**OHIO TURNPIKE AND
INFRASTRUCTURE COMMISSION**

ADDENDUM NO. 2
ISSUED JANUARY 16, 2020

PROJECT NO. 39-20-02 (PART A)
MAINLINE PAVEMENT RECONSTRUCTION
MILEPOST 46.50 TO MILEPOST 50.92
FULTON & LUCAS COUNTIES, OHIO
ISSUED DECEMBER 30, 2019

PROJECT NO. 39-20-02 (PART B)
TOLL PLAZA 49 SITE CONSTRUCTION
MILEPOST 48.8 TO MILEPOST 49.1
LUCAS COUNTY, OHIO
ISSUED DECEMBER 30, 2019

MAINTENANCE OF TRAFFIC PLAN - PHASE 1
STA. 12+50 TO STA. 25+50

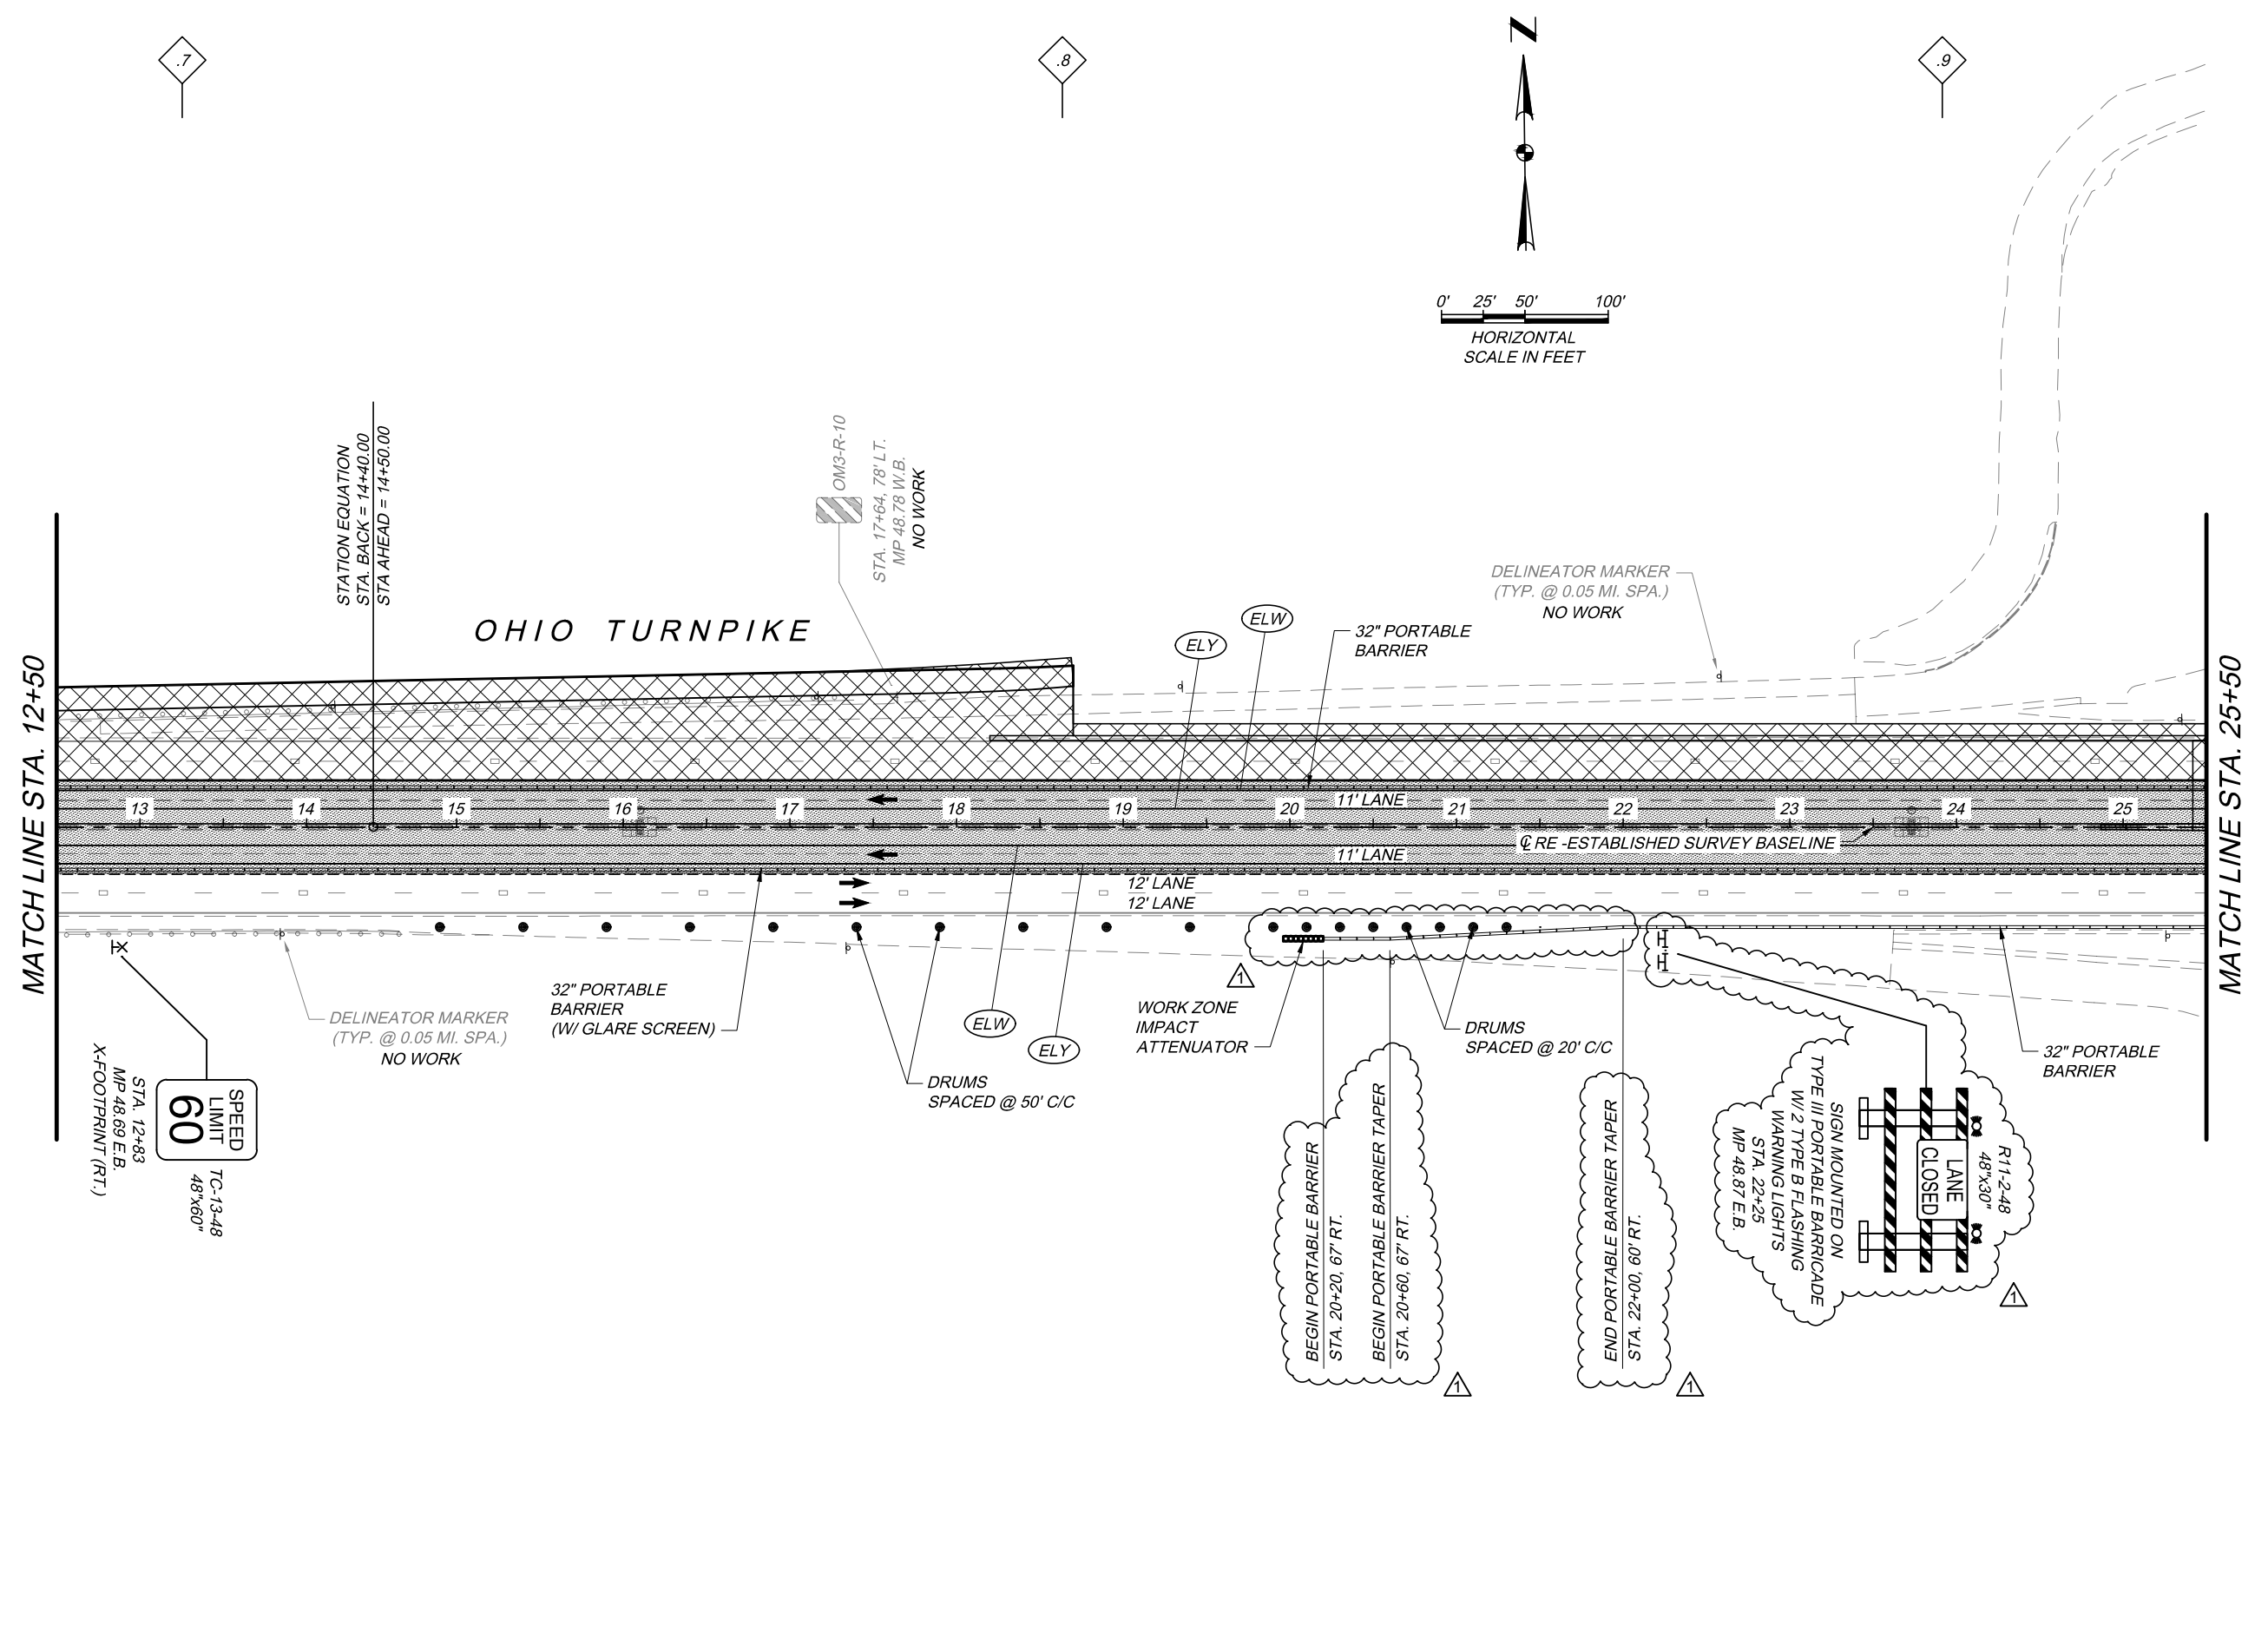
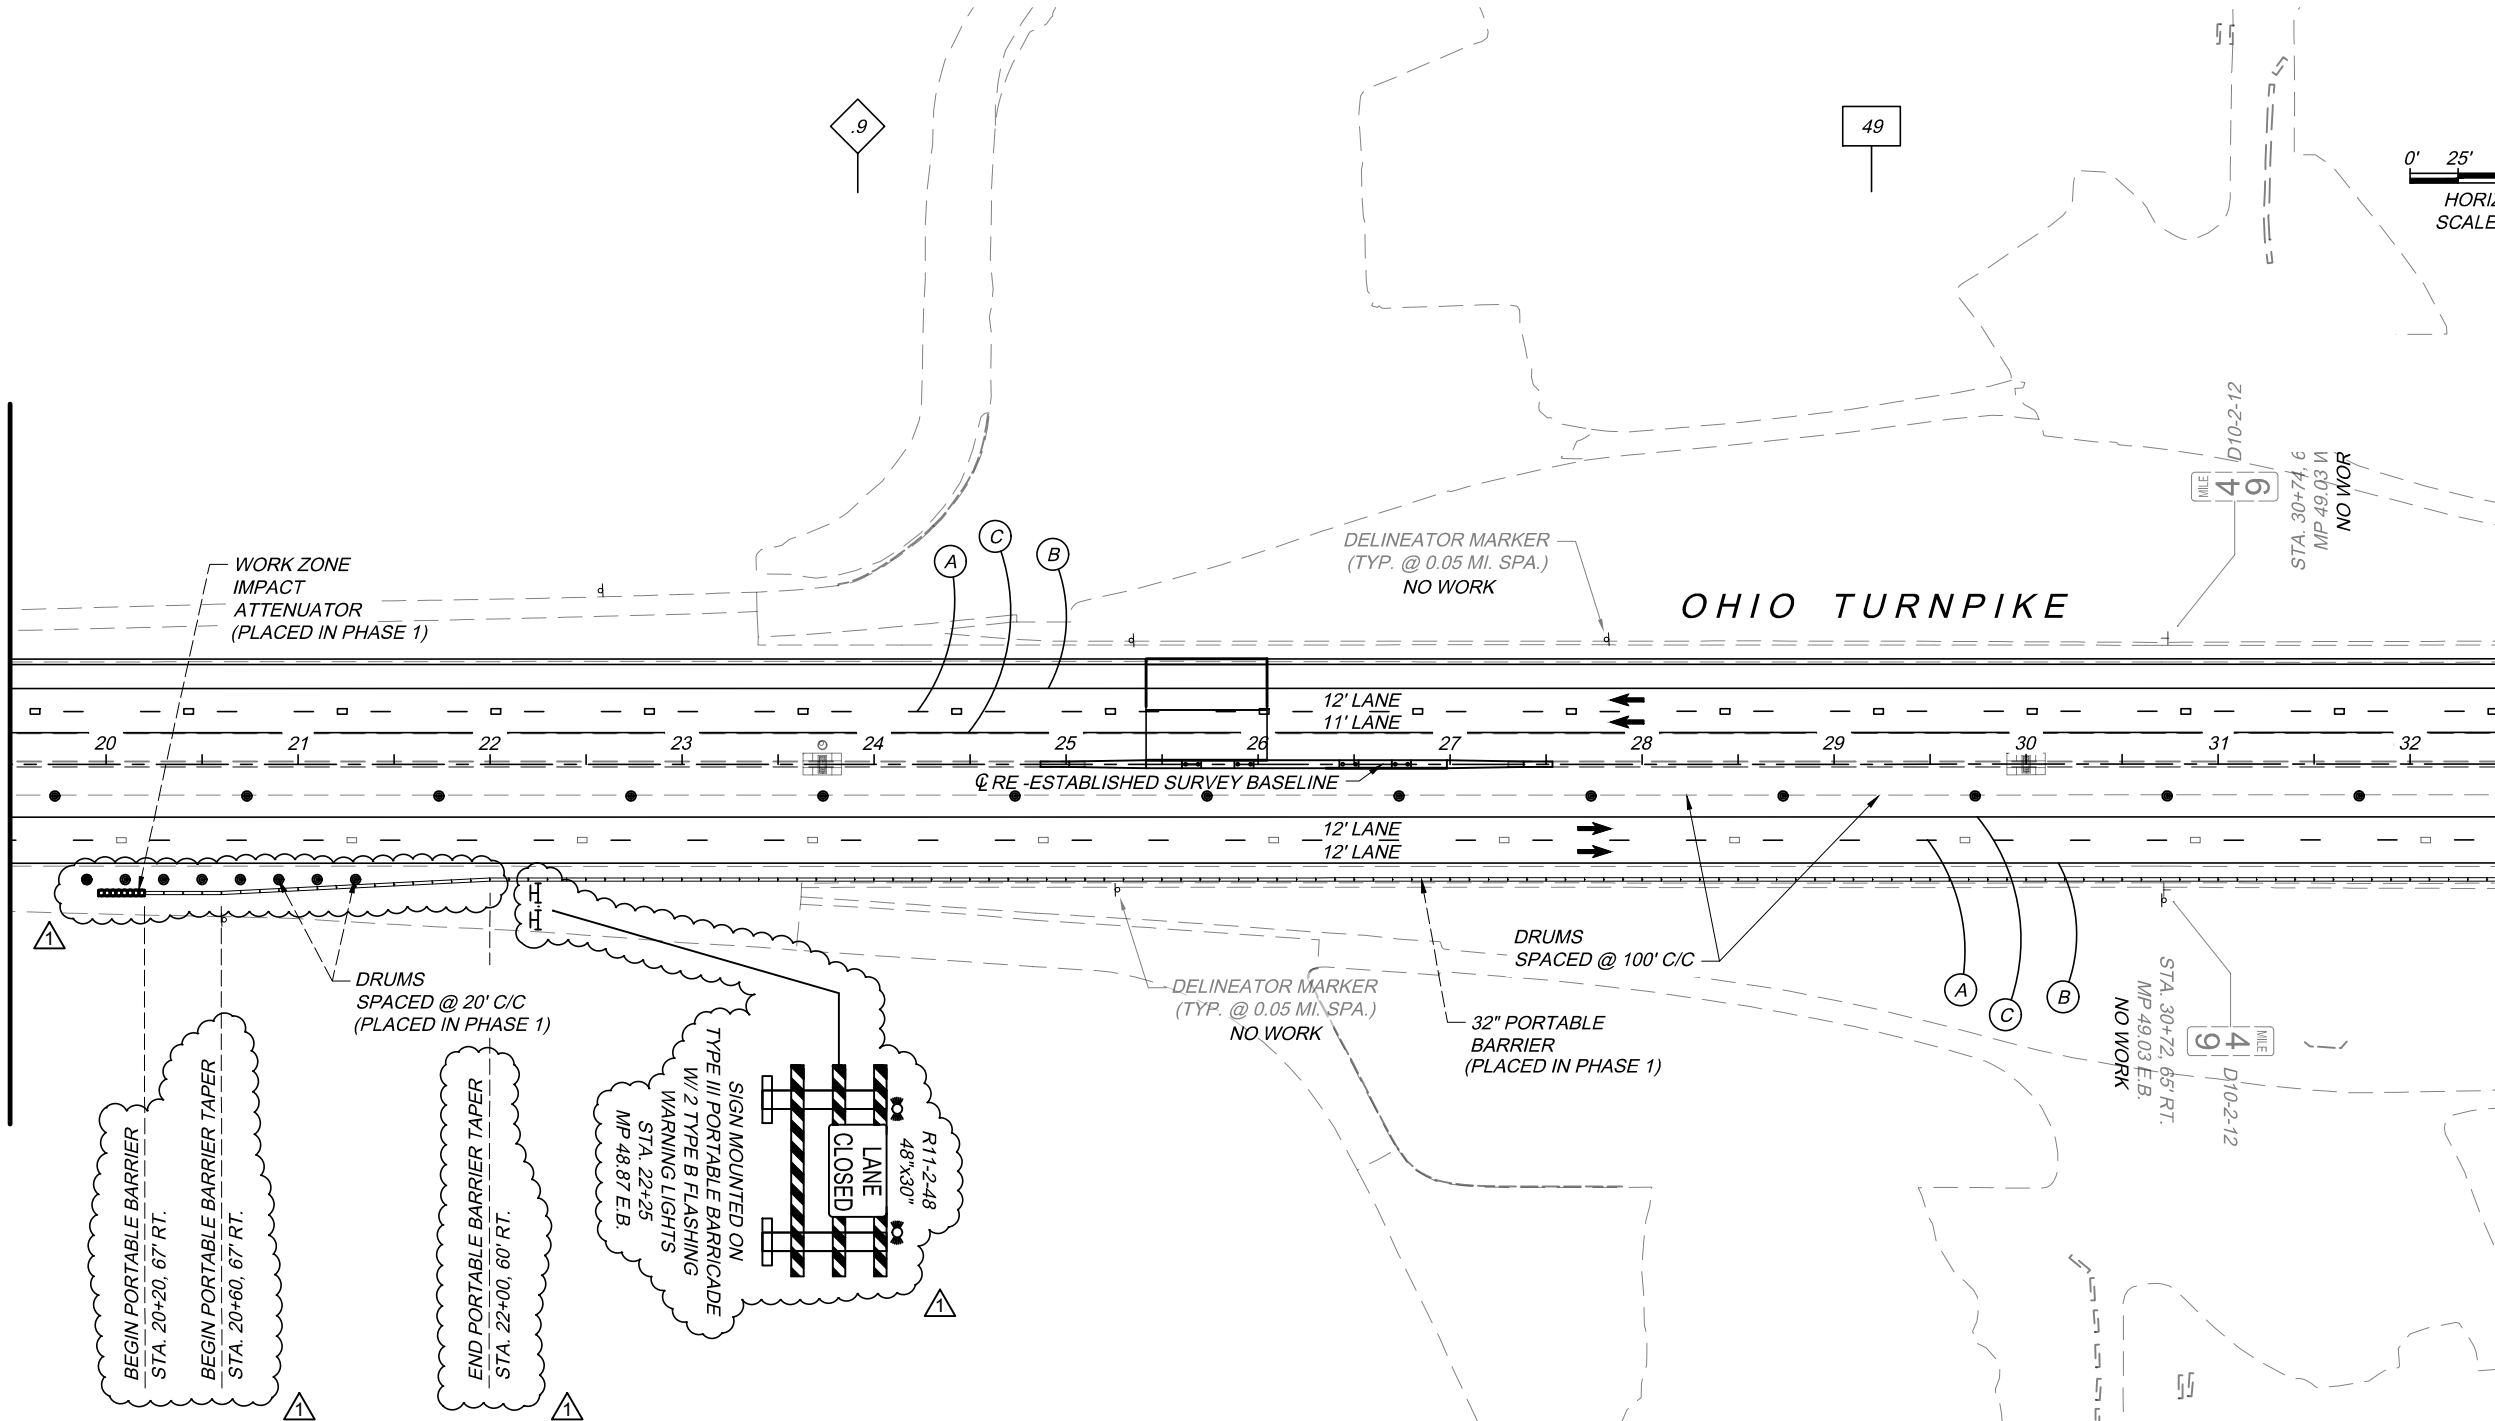
Q#31 Part B, sheet 13 shows EB toll plaza pavement work to be performed being built up through the SP302 prior to September 30, 2020. Assuming that these limits are from 118+69 through 133+70 (Part B- sheets 19 and 20), then there is a conflict with the Part A maintenance of traffic plan sheet 78 which shows the portable barrier in phase 1 starting at 21+70. Should this PCB taper in phase 1 be extended to the west so that pavement construction on the EB plaza can begin accordingly? Please review the part A MOT plan as it relates to EB part B construction and revise the MOT sheets as required in an addendum.

A#31 This Addendum No. 2 revises Part A Maintenance of Traffic Sub Summary Sheet No. 42 and Maintenance of Traffic Plan Sheet Nos. 78, 109 and 126 of 505 to extend the portable barrier to STA 20+20, 67' RT to avoid conflict with the Contract 58-20-01 staging areas to be constructed in this Contract prior to September 1, 2020 as shown on Part B Sheet 9 of 59. A note was modified on the Contract Coordination Plans, Sheet 13 of 59 to further describe what portion of SP 302 is to be performed on the Eastbound Toll Plaza prior to the September 1, 2020.
